NOTICE OF PUBLIC HEARING – SEPTEMBER 26, 2022

BYLAW 2438:WHITE ROCK ZONING BYLAW, 2012, NO. 2000, AMENDMENT
(RT-1 1091 STAYTE ROAD) BYLAW, 2022, NO. 2438

CIVIC ADDRESS: 1091 STAYTE ROAD

PURPOSE: Bylaw 2438 proposes to rezone the subject property from the "RS-1 One-Unit Residential Zone" to the "RT-1 Two-Unit (duplex) Residential Zone". If approved, it would allow for the construction of a duplex on the property.

LANDSCAPE PLAN

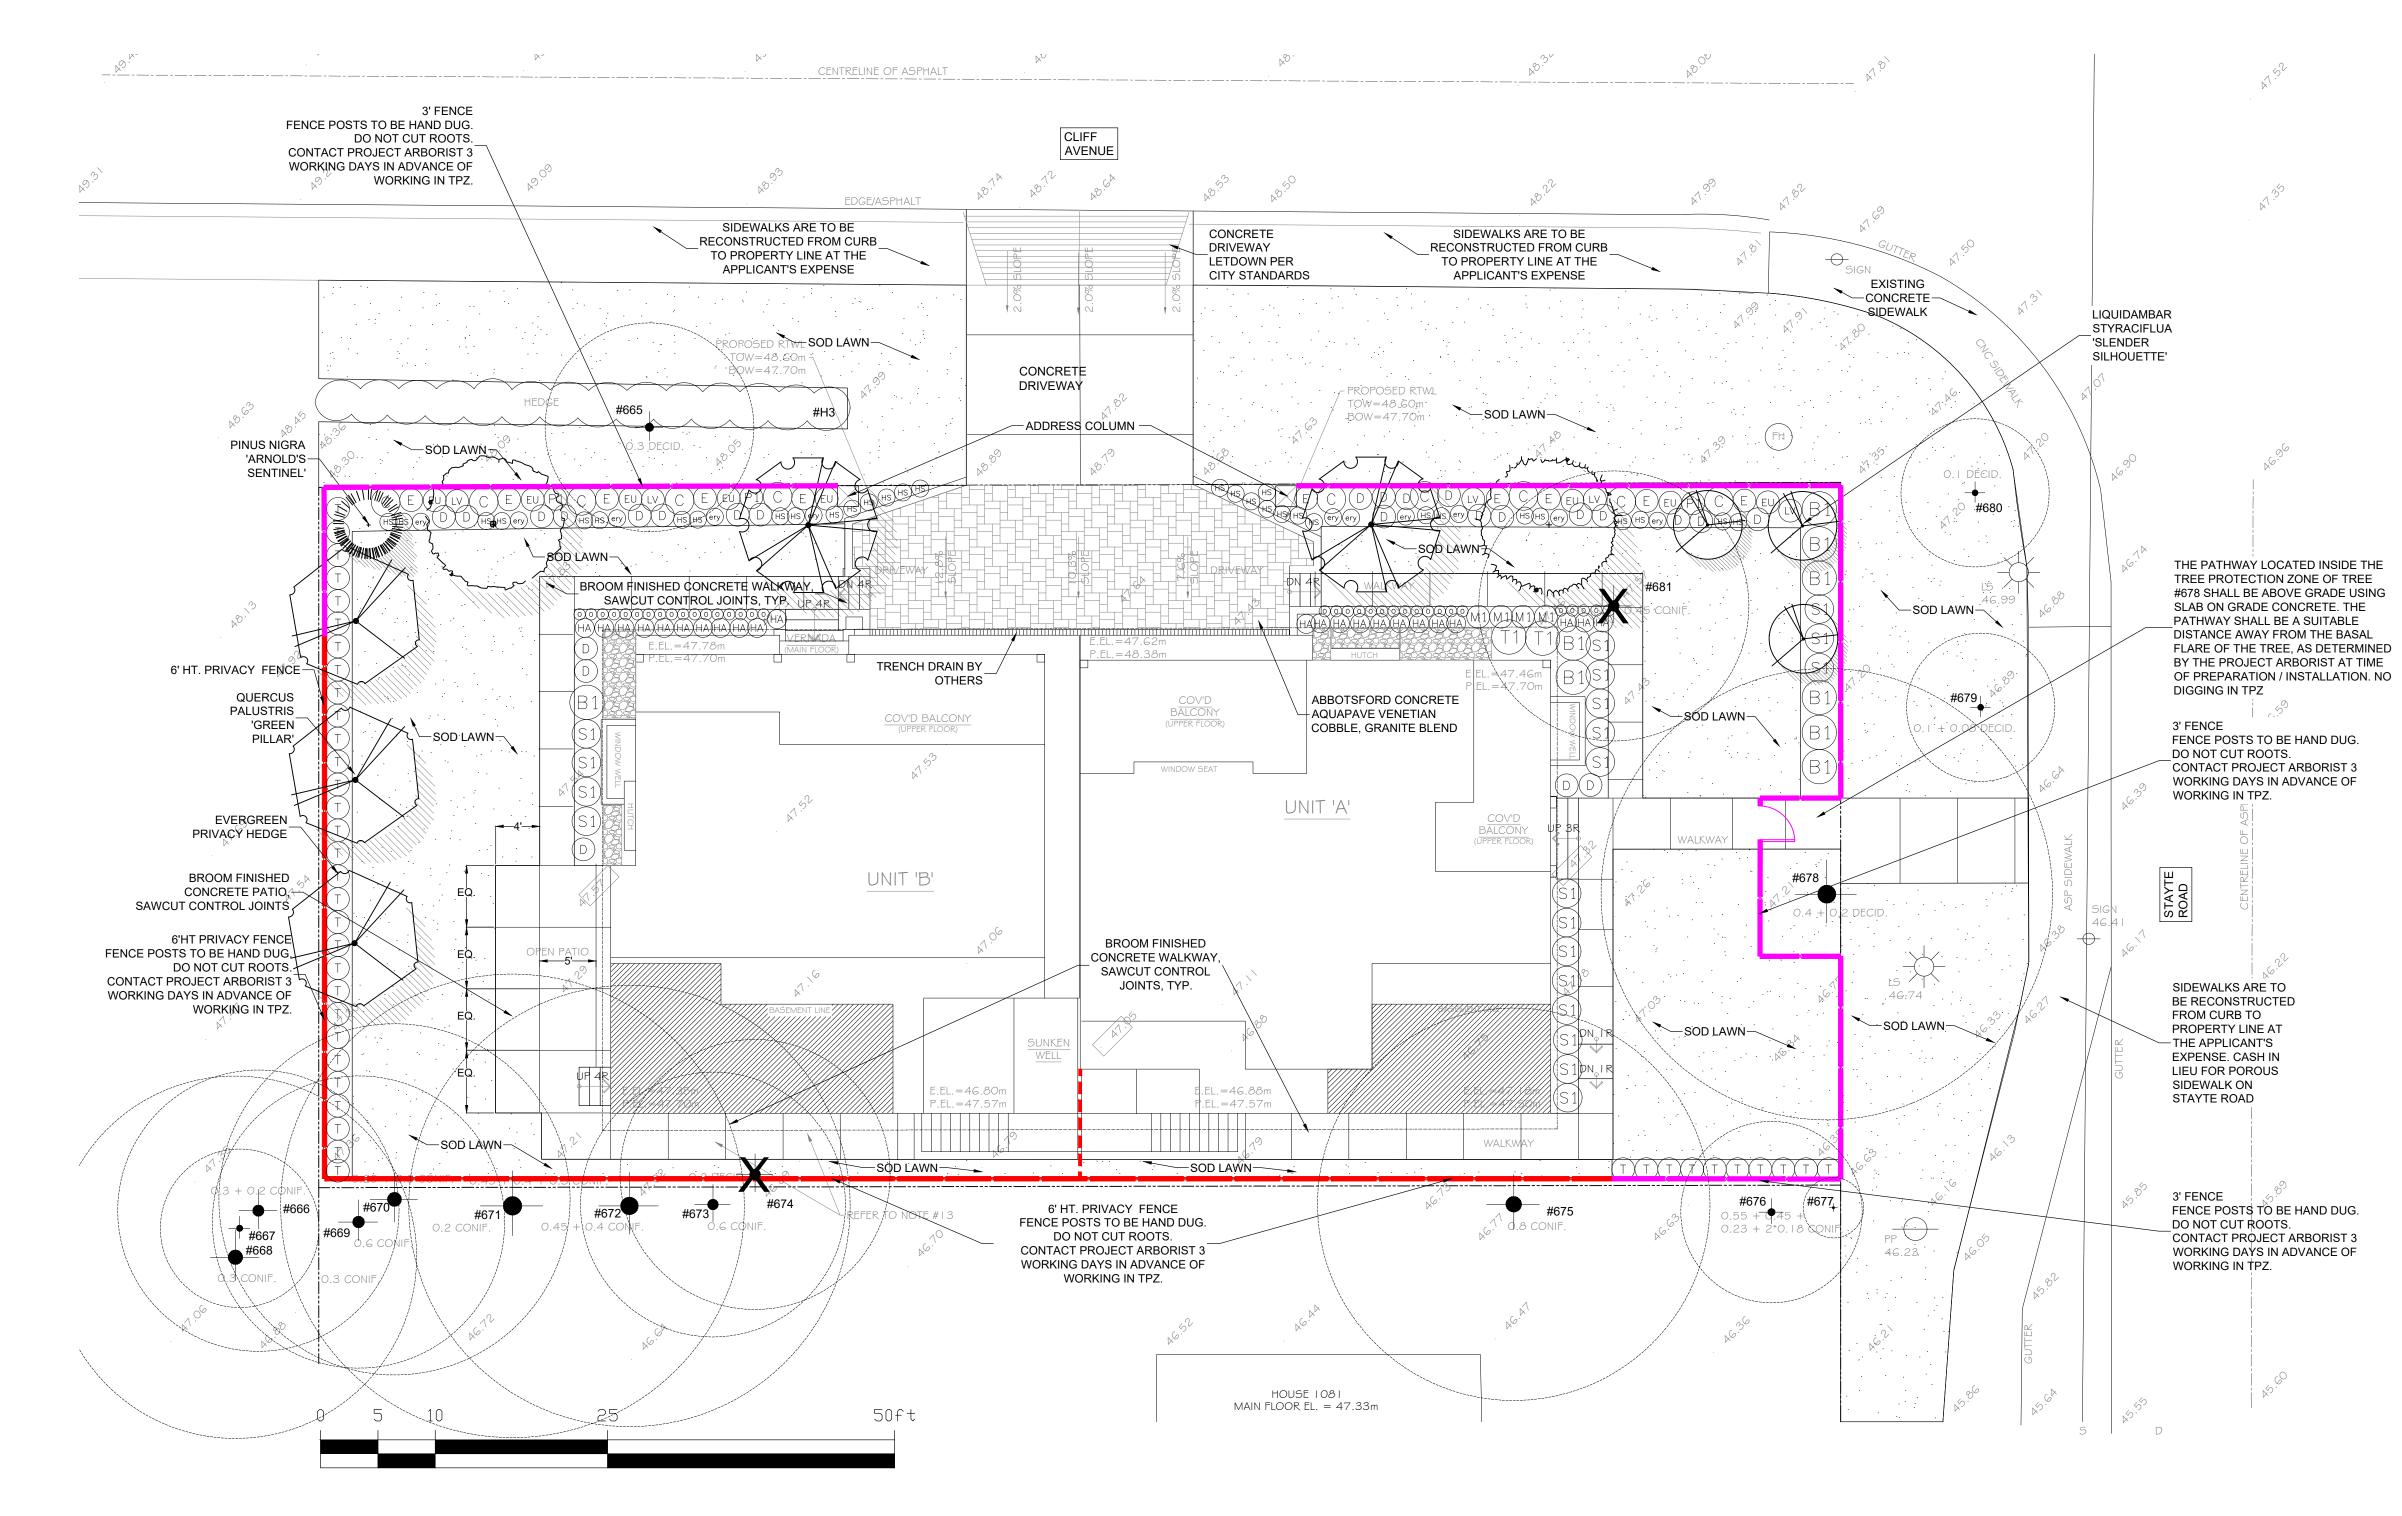
- A member of the Panel recommended using a different variety of tree and plant species along the property line. It was suggested that utilizing different tree and plant species may also reduce the need for a large fence.

Table 2: ADP comments and Applicant's responses ADP Comments	Applicant's response
Consider using a different variety of tree and plant species along the property line to reduce the need for a large fence	 The plantings have been revised. The proposed fence does not exceed the zoning bylaw's maximum fence height requirement. It was advised that coordination with the Arborist is required to avoid damaging the tree roots. Notes have been included in the updated Landscape Plan; the posts are to be hand dug under Arborist supervision.
To use colours and elements from the front elevation on the rear elevation.	• The colours and elements on the rear elevation have been revised to match that on the front elevation.
Revise the design to replace the horizontal windows with larger vertical windows.	• The horizontal window has been replaced by a larger window.
To include roughed-in electric vehicle charging infrastructure.	• Plans updated to include a rough-in outlet for EV charging.
